SURVEYOR'S OFFICE  
**Hamilton County**

Re: J. W. Brendel Drain, Lakeside Park Section 2 Arm

**Re: JW Brendle Drain: Lakeside Park Sec. 2 Arm**

Attached are as-builts, certificate of completion & compliance, and other information for Lakeside Park Sec. 2. An inspection of the drainage facilities for this section has been made and the facilities were found to be complete and acceptable.

SHEET NO. 4  
 OF 21 SHEETS  
 JOB NO. 41760

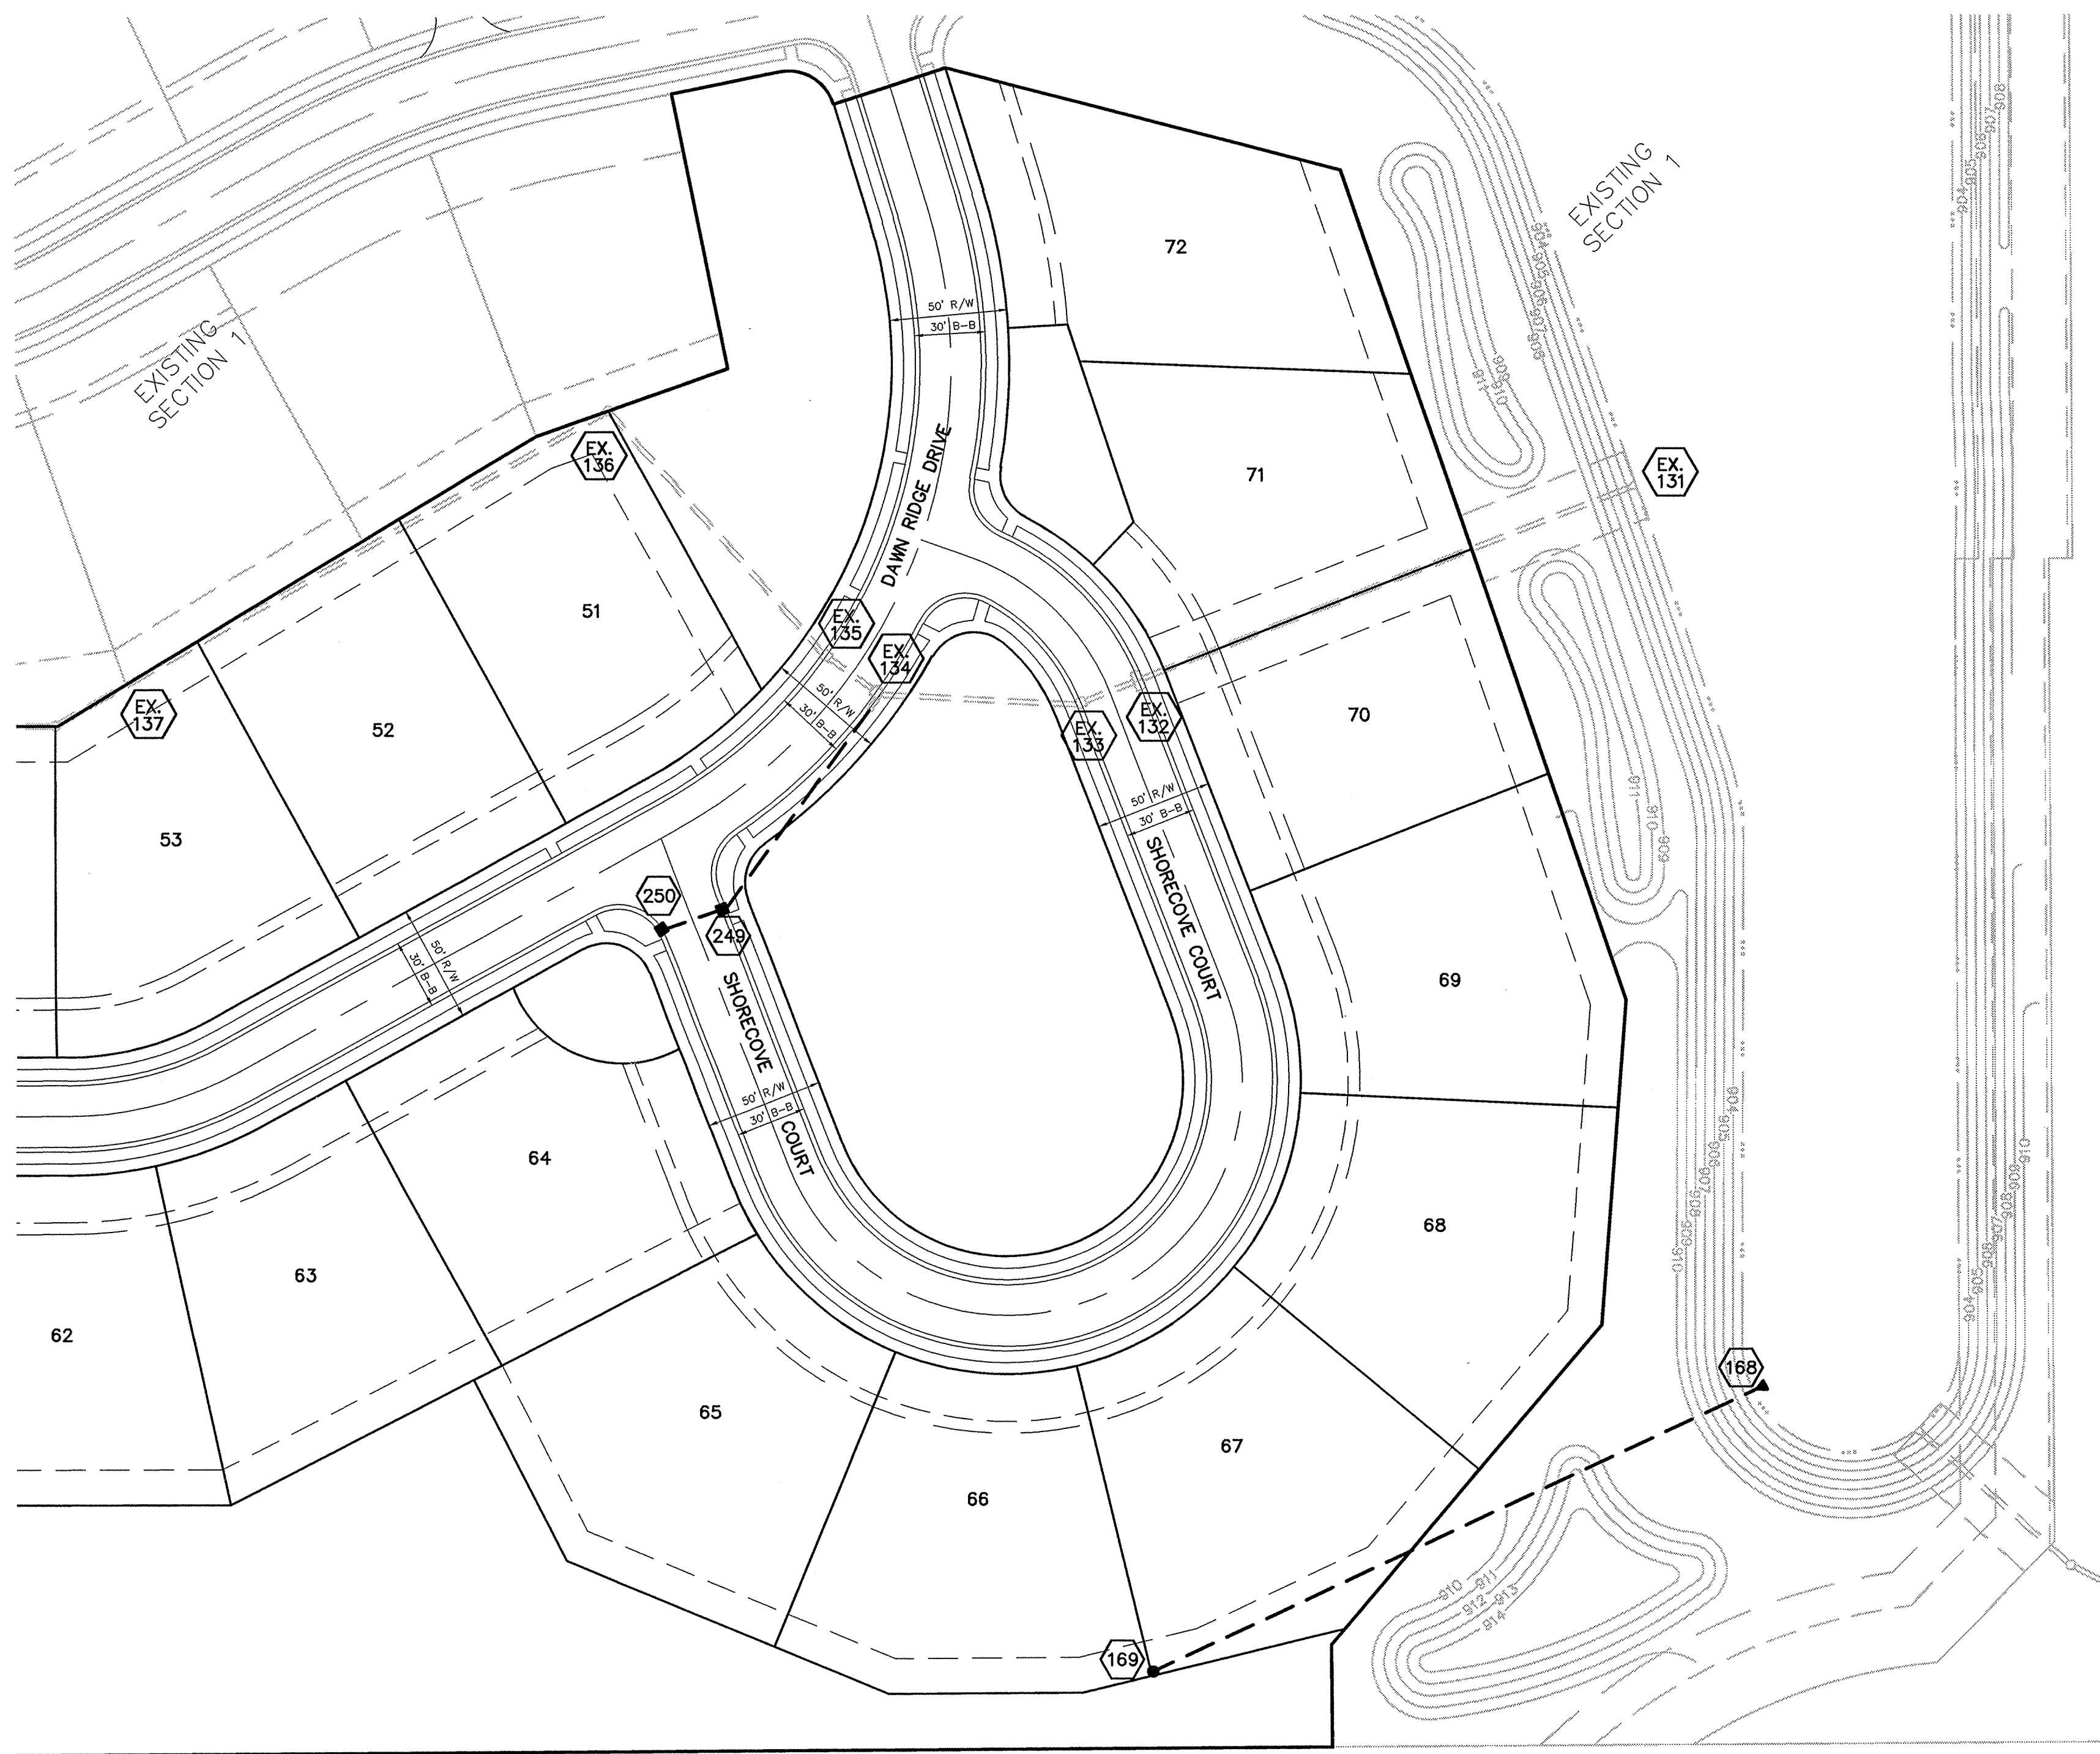
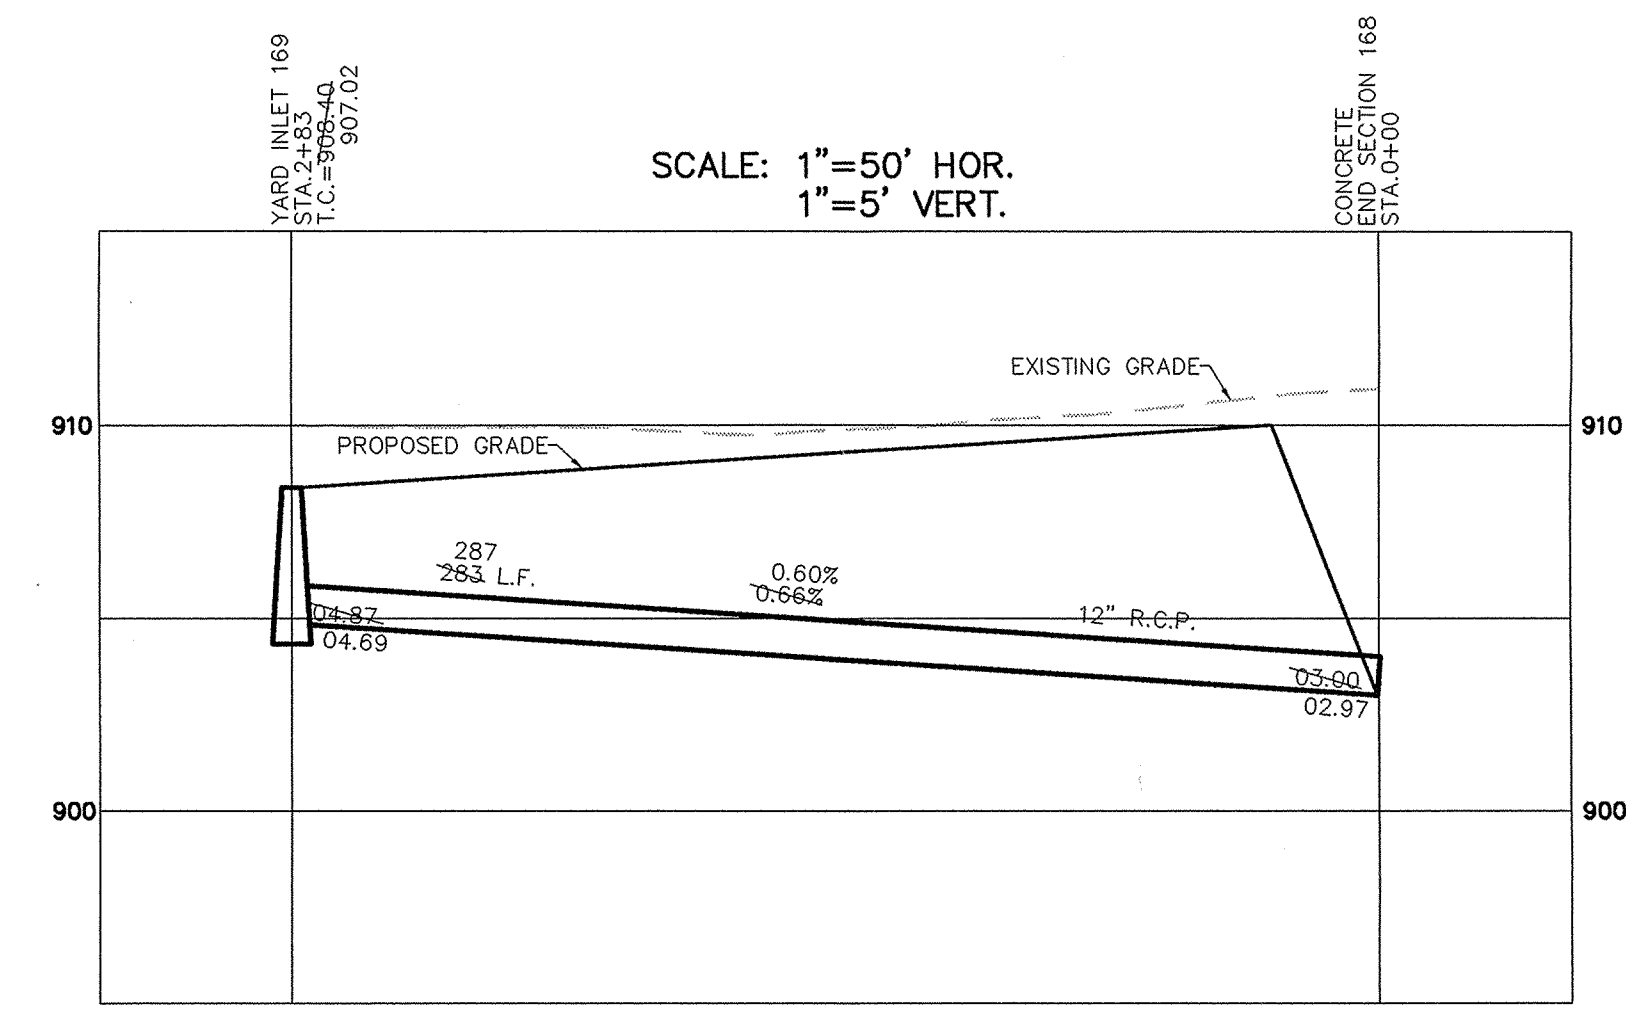
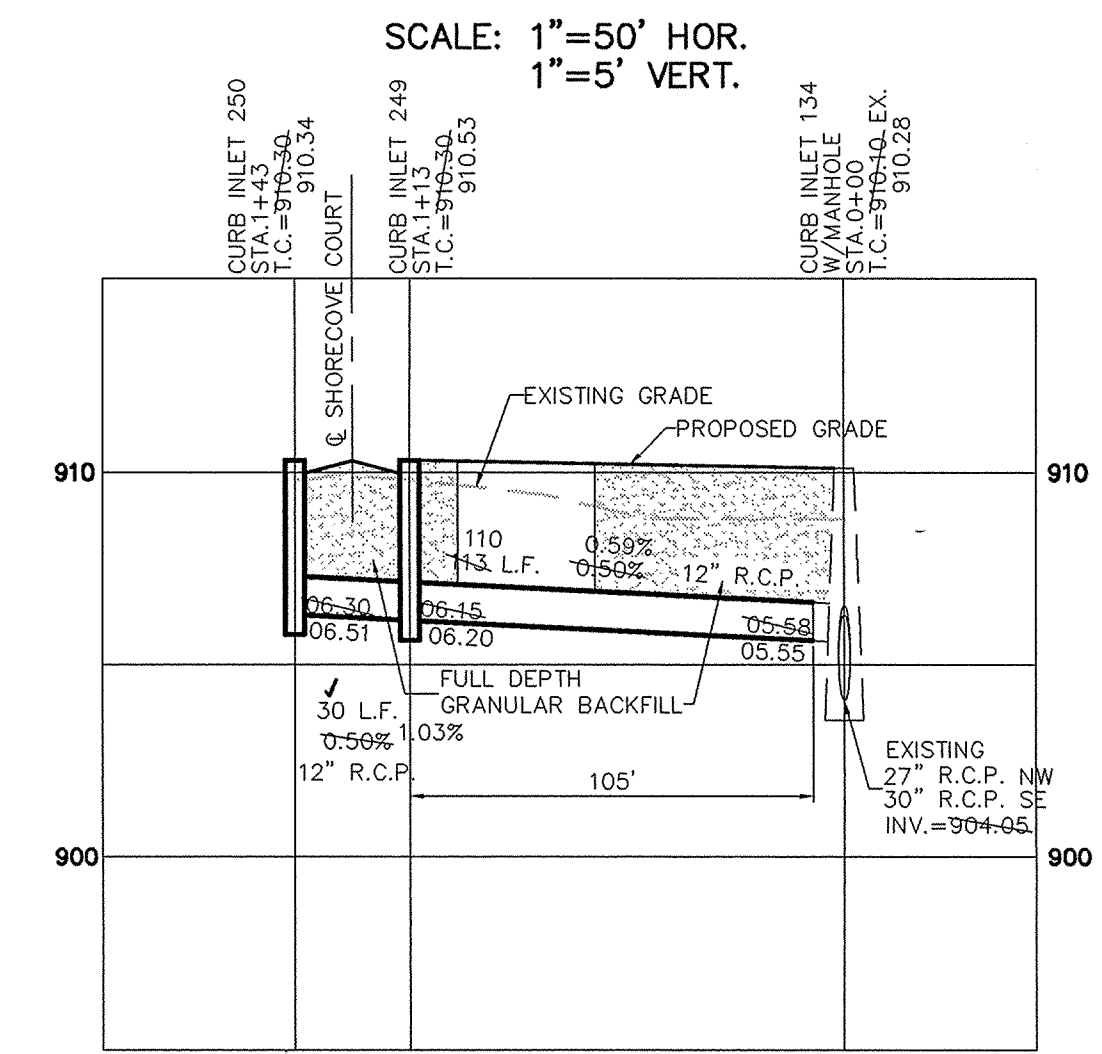
During construction, changes were made to the drain, which will alter the plans submitted with my report for this drain-dated March 24, 2003. The report was approved by the Board at the hearing held April 28, 2003. (See Drainage Board Minutes Book 7, Pages 52-53)

Structure:	T.C.:	I.E.:	Pipe:	Length:	Grade:	Original:	Difference:
257	912.35	909.25					
256	912.3	908.54	12	36	1.97		
256	912.3	908.54					
255		904.95	12	63	5.7	58	5
107	911.88	908.68					
106	911.9	908.14	12	36	1.5		
106	911.9	908.14					
105		904.95	12	68	4.69	62	6

The length of the drain due to the changes described above is now **1,924 feet**.
